NUMBER: 11-001-14
GROUP: Exhaust System
DATE: January 15, 2014

SUBJECT:
 Weld Length on Exhaust Hanger Bracket Too Short

OVERVIEW:
 This bulletin involves inspecting the Selective Catalytic Reduction (SCR) inlet exhaust hanger bracket weld length and increase the weld length if too short.

2013	DD	Ram 3500 Cab Chassis
2013	DP	Ram 4500/550 Cab Chassis

Fig. 1 SCR Hanger Bracket

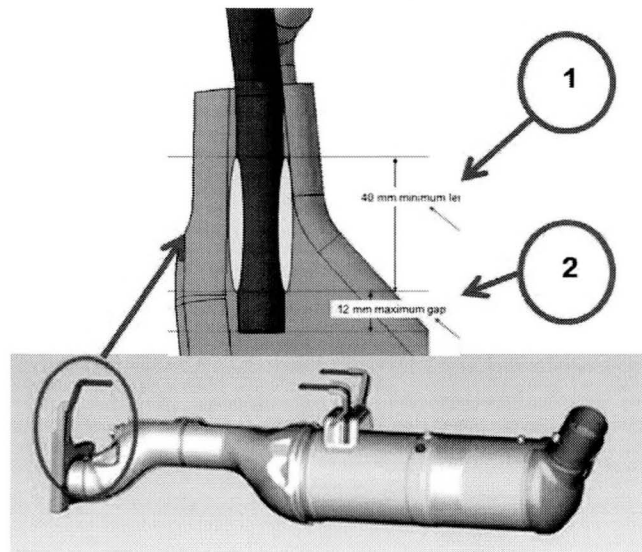
- 1 - Minimum Weld Length is 40mm (1.57 in.)
2 - Minimum Weld Distance From Rod End is 12mm (0.47 in.)
-

Fig. 2 Weld End Gap

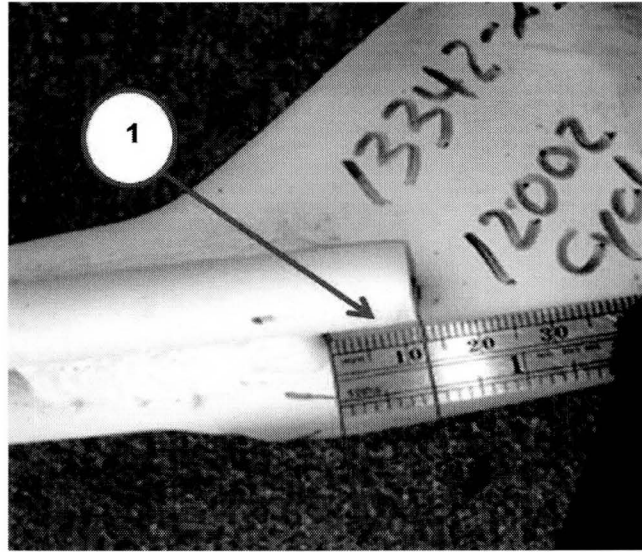
3. Measure the distance from the end of the hanger rod to where the weld starts to secure the rod to the bracket (Fig. 2).

1 - Minimum Weld Distance From Rod End is 12mm (0.47 in.)

4. Is the distance 12mm (0.47 in.) or less?
 - a. YES>>>Continue to the next step.
 - b. NO>>>Proceed to Step #7 (dealer repair) or Step #19 (sublet repair).
5. Measure the length of the rod to bracket weld on each side of the rod (Fig. 3).

Fig. 3 Weld Length

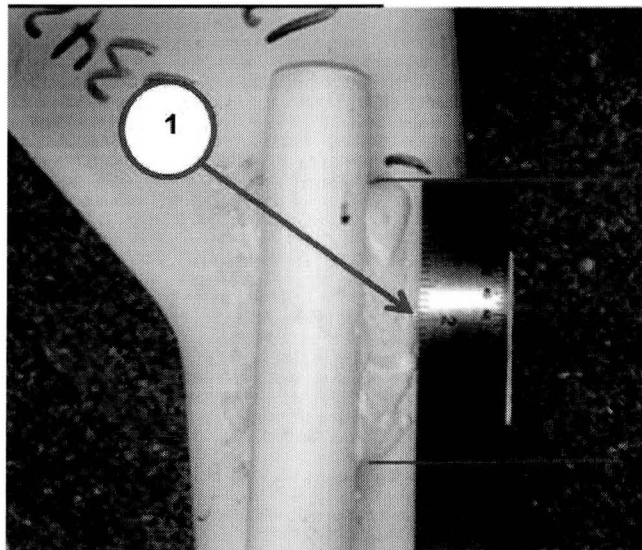
1 - Minimum Weld Length is 40mm (1.57 in.)

6. Is the length of the rod to bracket weld 40mm (1.57 in.) or longer on each side?
 - a. YES>>>Inspection complete. No additional work is necessary.
 - b. NO>>>Proceed to the next step.

Fig. 5 Reinforce Weld to a Length of 60mm

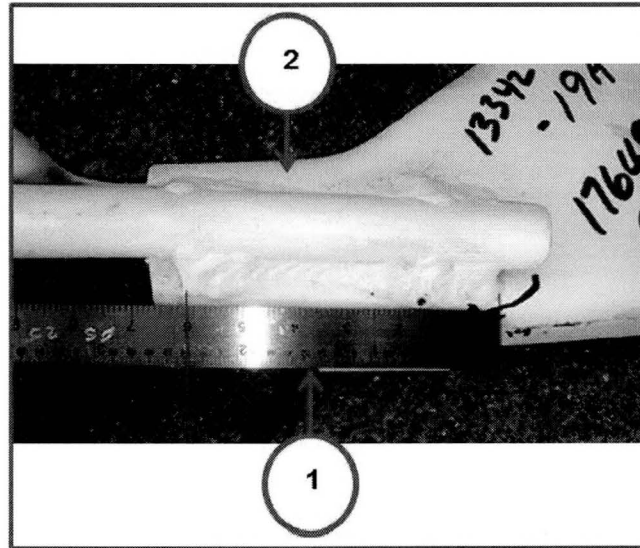
-
9. Remove the rubber isolator connected to the hanger rod to be repaired.
 10. Disconnect the electrical harness from the urea injector.
 11. Disconnect the electrical harness from all of the sensors (4 sensors total).
 12. Using a clean rotary wire-brush, remove any rust and/or debris from the area to be welded and the area where the ground clamp will be attached. Attach the ground clamp to either the hanger rod or the bracket.
 13. Add additional flare-groove weld length with GTAW ("TIG" weld) using a 90-degree torch with a stub back-cap adding 409SS wire to reach a minimum required length (60mm (2.36 in.)) on each side of the hanger rod (Fig. 5). The GTAW power supply should be set to a mode with High Frequency (HF) in Start Only: HF shuts off shortly after the arc is established. This gives better protection to electronic system components.

- 1 - Increase Weld Length to 60mm (2.36 in.)
- 2 - Increase Weld Length to 60mm (2.36 in.)

Fig. 6 Reinforce Weld to a Length of 60mm

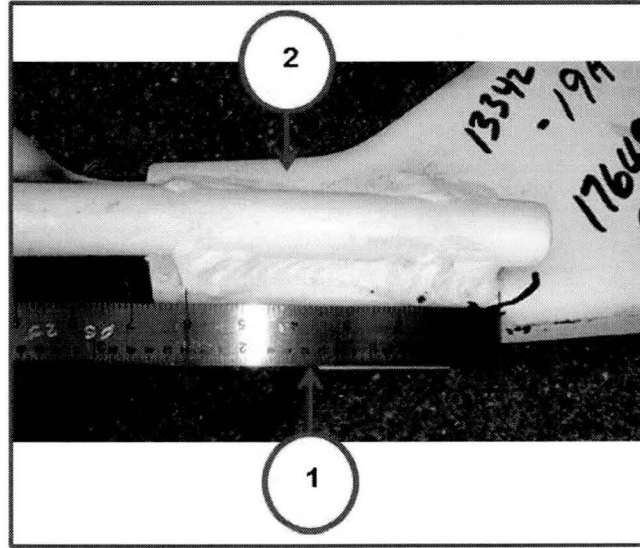
- 20. Using a clean rotary wire-brush, remove any rust and/or debris from the area to be welded and the area where the ground clamp will be attached. Attach the ground clamp to either the hanger rod or the bracket.
- 21. Add additional flare-groove weld length with GTAW ("TIG" weld) using a 90-degree torch with a stub back-cap adding 409SS wire to reach a minimum required length (60mm (2.36 in.)) on each side of the hanger rod (Fig. 6). The GTAW power supply should be set to a mode with High Frequency (HF) in Start Only: HF shuts off shortly after the arc is established. This gives better protection to electronic system components.

- 1 - Increase Weld Length to 60mm (2.36 in.)
- 2 - Increase Weld Length to 60mm (2.36 in.)
